Pacific Grove Unified School District
435 Hillcrest Avenue, Pacific Grove, CA 93950
PGAS Building F Demolition & Utility Relocation
Notice to Bidders - Addendum 02

Addendum Date: 10/15/2026

Addendum by: Ausonio Incorporated/Brailsford & Dunlavey

AD02-01: Bid Walk Sign-in and Agenda

Attachment per question 12

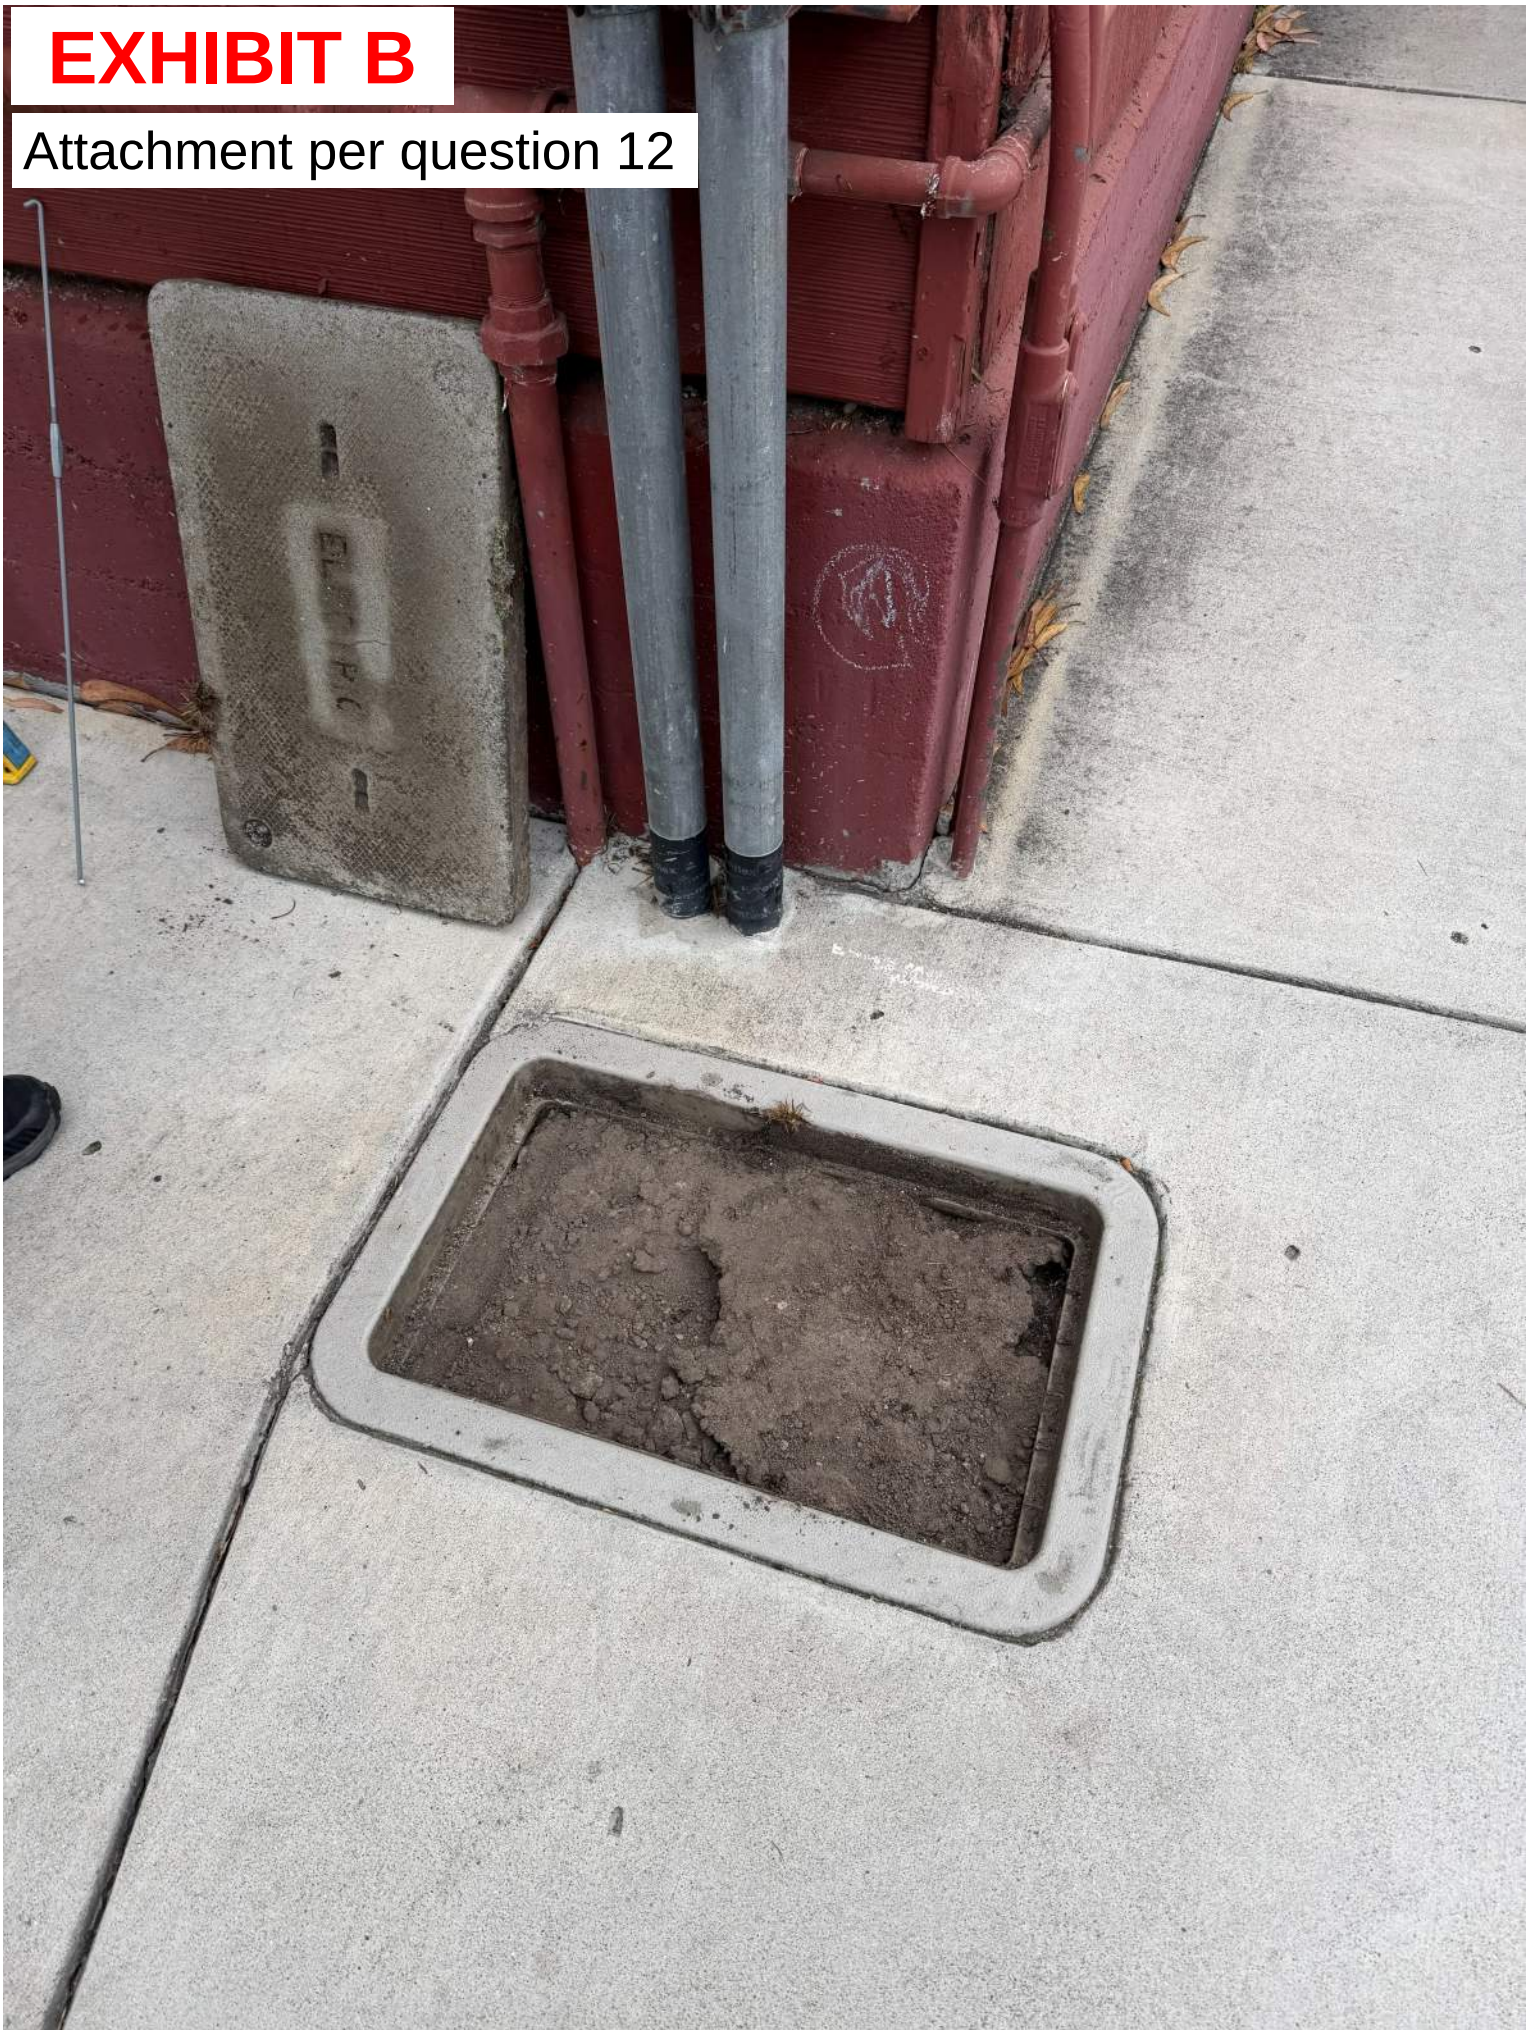
12	Will the box be replaced or hardened to prevent filling once again with dirt/water (see pic attached)?	Box will remain.
13	Full access to bldgs. E and Q will be available during the winter break work window (12/12/26 - 1/3/27)? Full access to the fire alarm control unit in the main building will also be required (programming/testing, etc.). Is final testing with State officials expected to be done during this winter break period?	Contractor required to install fire alarm devices and complete testing within winter break window (December 19-January 3), when class is not in session. Access to buildings will be made available.
14	Sealed bids are due October 22. The notice header lists 433 Hillcrest Avenue. Notice paragraph 1 and the Instructions list 435 Hillcrest Avenue. Which address receives the sealed bid?	435 Hillcrest Avenue at the Pacific Grove Unified School District Office
15	The Instructions require a Site Visit Certification with the bid. That form is not in the manual. Is the October 1 job-walk sign-in sufficient?	Site Visit Certification is not required with bid.

Drawing Title:
ELECTRICAL SITE PLAN

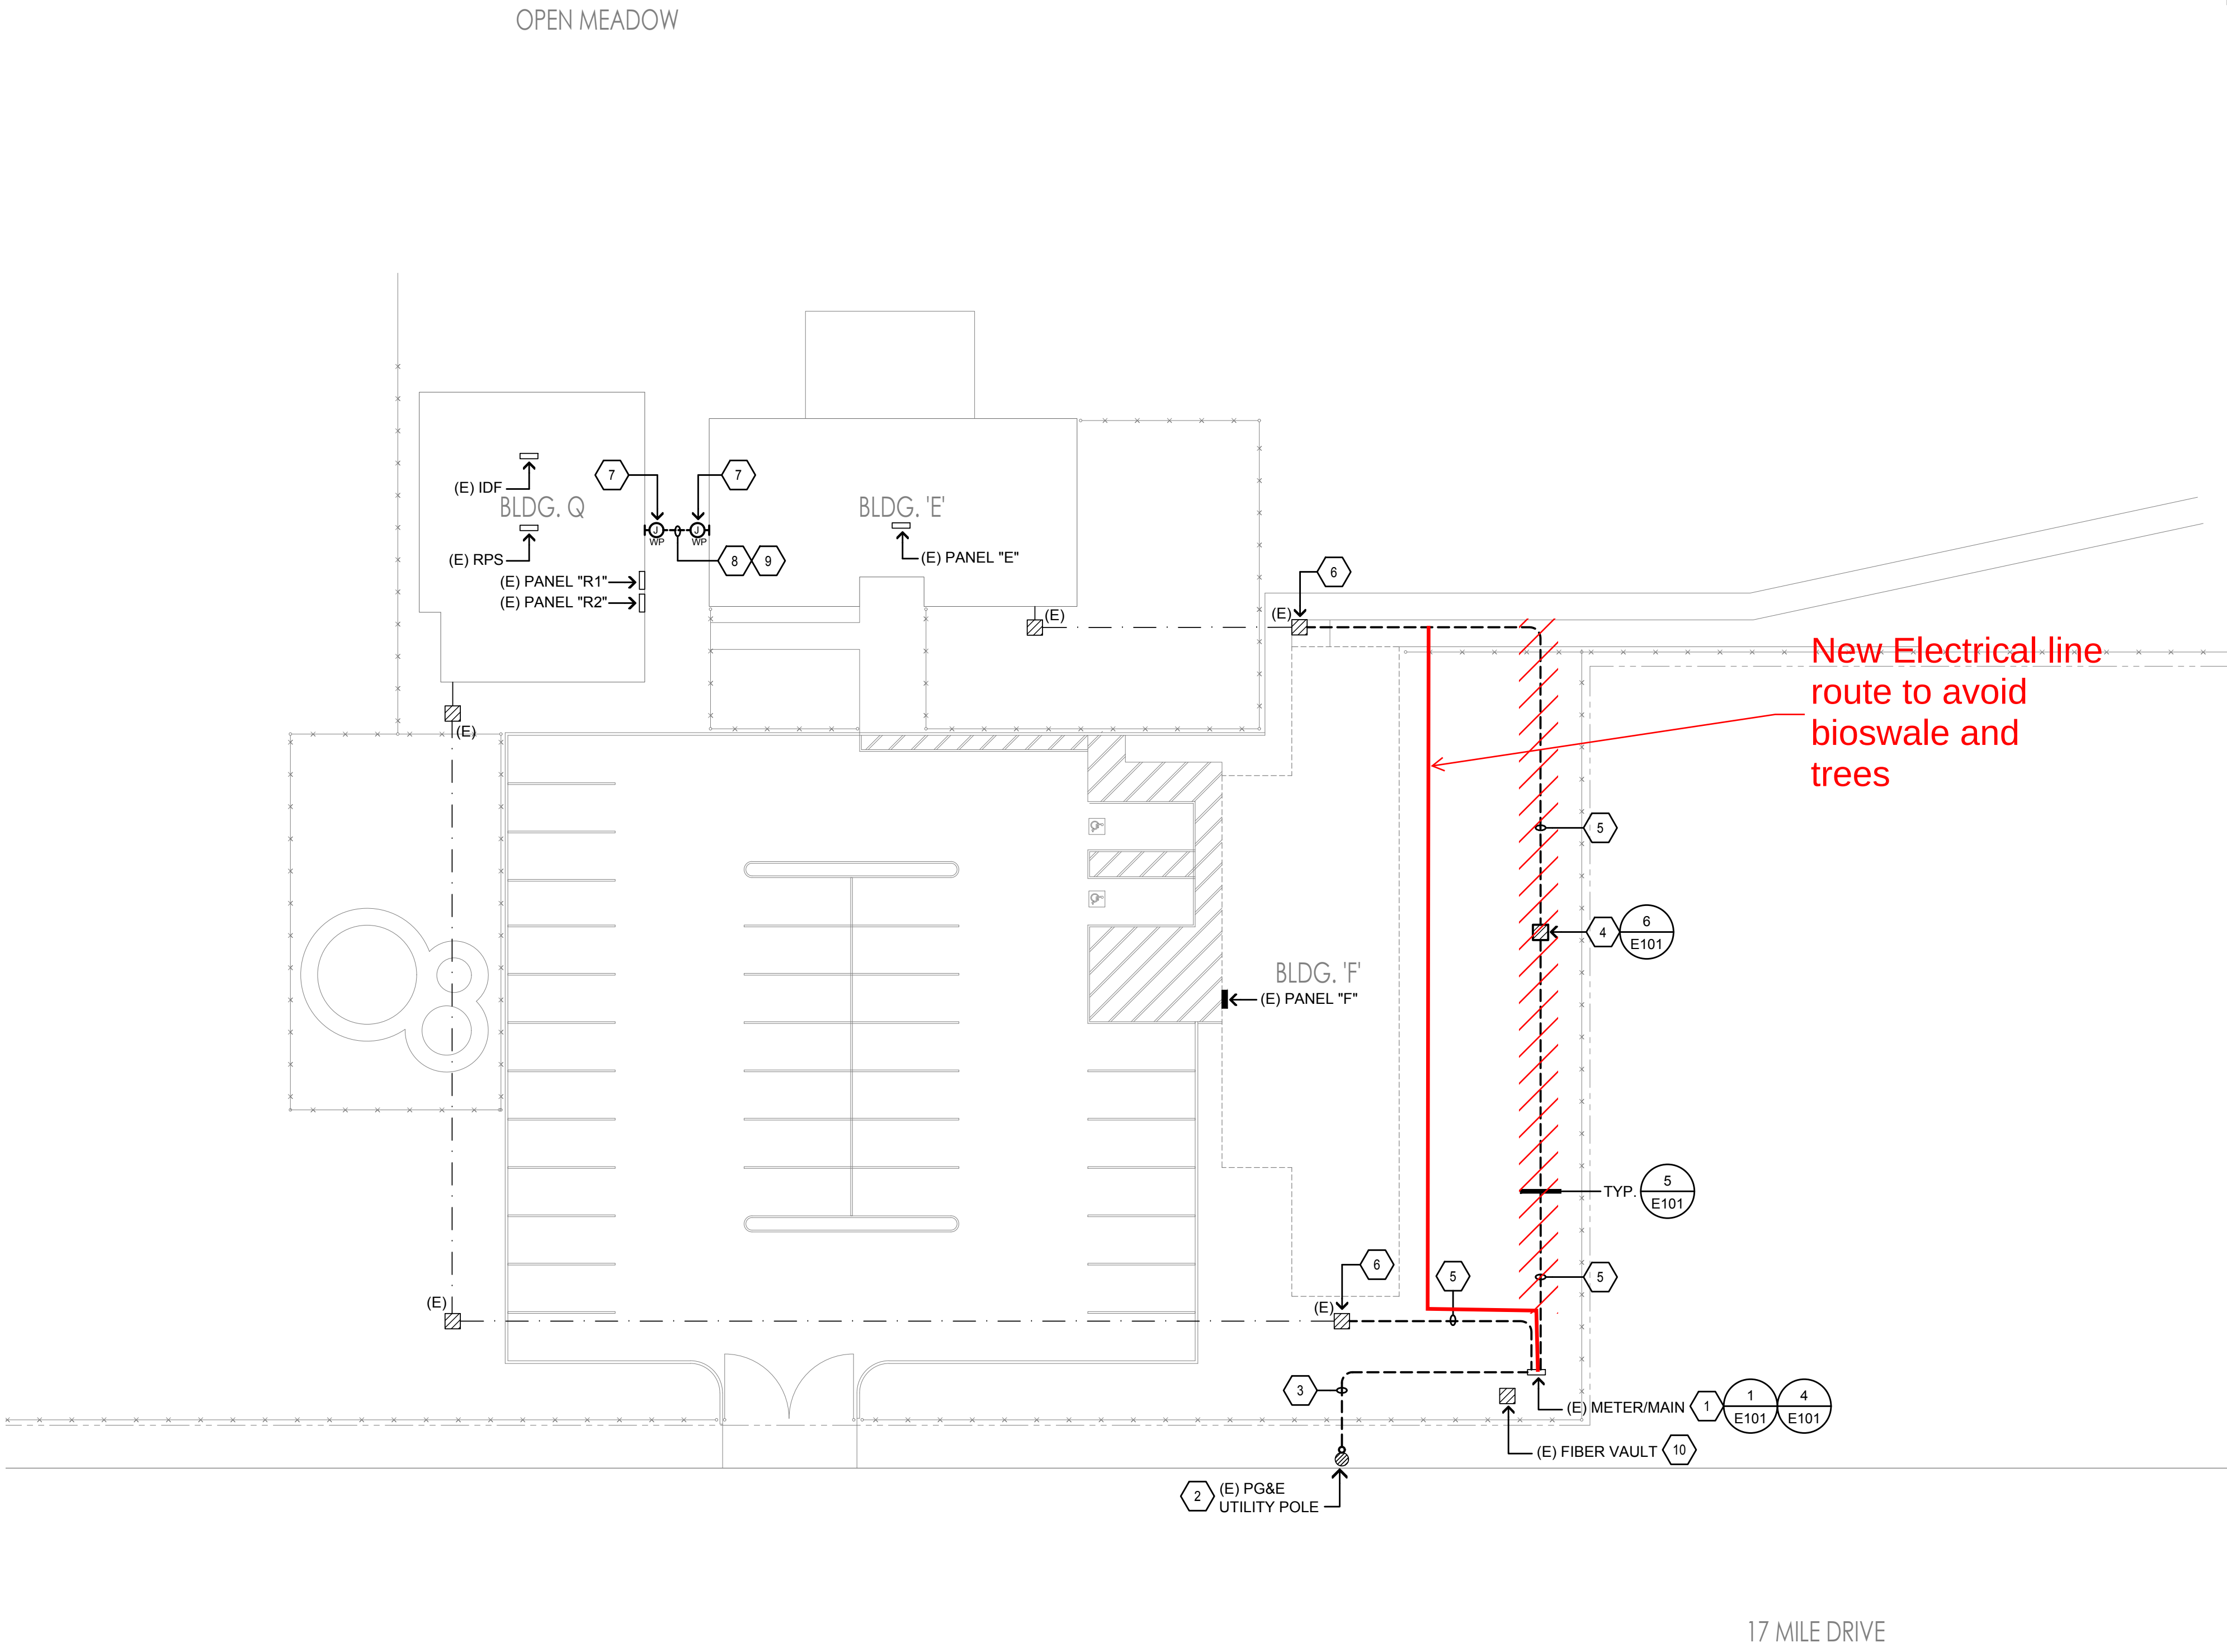
New electrical and gas line routes outlined and attached as Exhibit D

Existing Junction Boxes

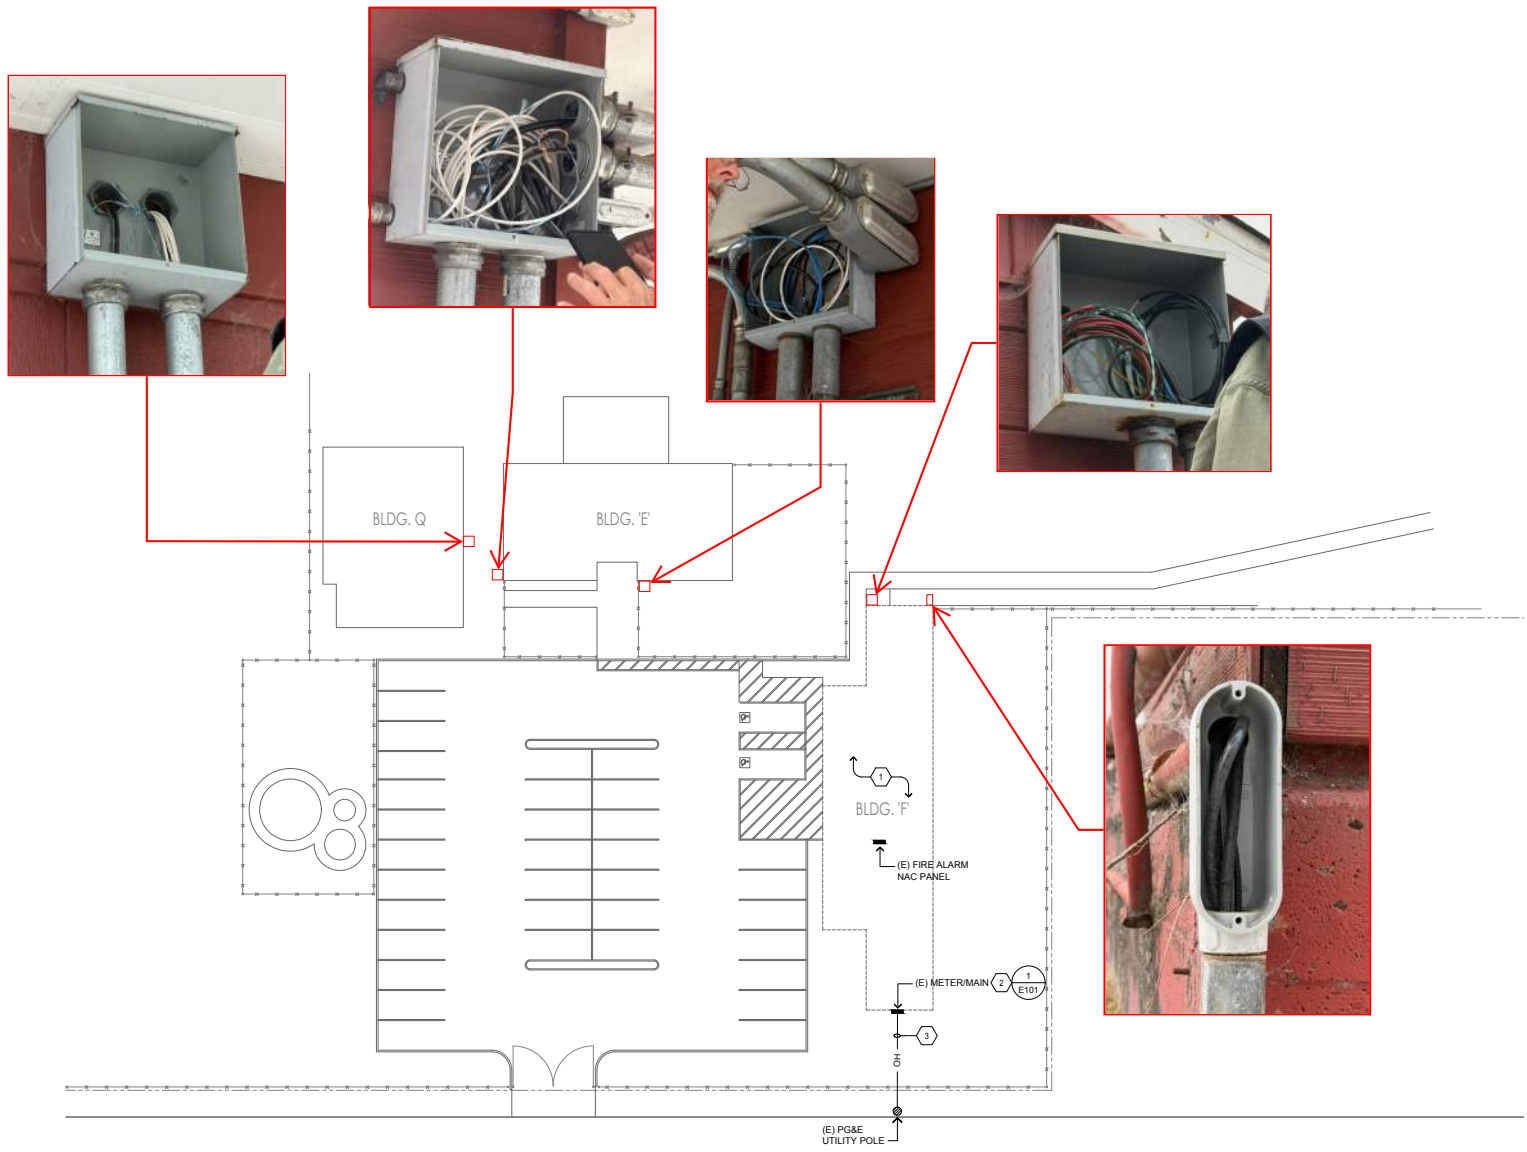
Site-plan of existing junction boxes with pictures attached as Exhibit E
